AIRWORTHINESS ADVICE NOTICE

TYPE AFFECTED: Janus, Janus B and Janus C

SUBJECT: Miscellaneous airworthiness information.

GFA AN 37	ISSUE: 5	24 August 2001	Page 2 of 3
-----------	----------	----------------	-------------

L'Hotellier coupling set up

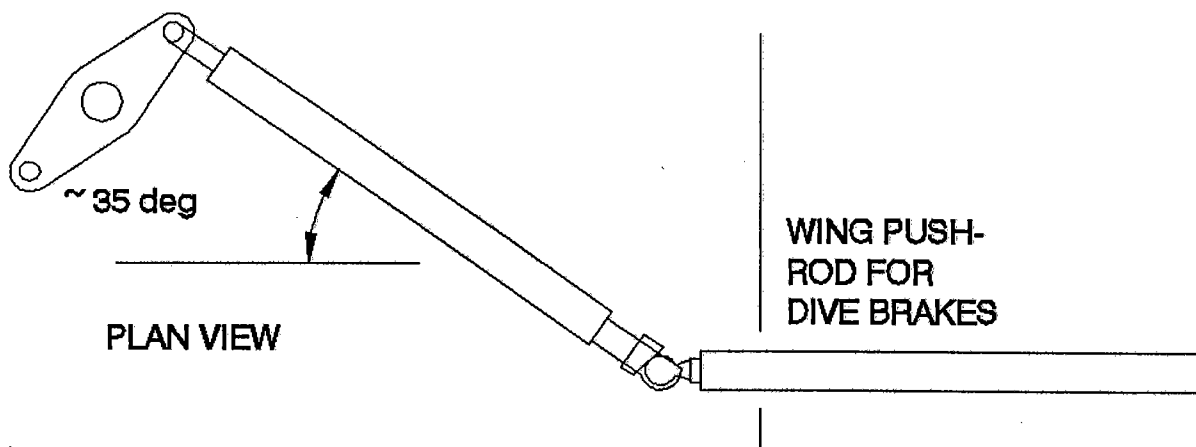
1. During an annual inspection of a Janus B the L'Hotellier balls and couplings were found to be galled after only 150 hours in service. It was found that the balls were binding when the dive brakes were actuated because the coupling had been rotated during maintenance to couple from the top rather than the side.

To provide sufficient angular movement the couplings in the dive brake circuit should be installed on their sides as shown below. Note: the diagram in the Maintenance Manual would indicate that the couplings should all connect from the top, which is not correct.
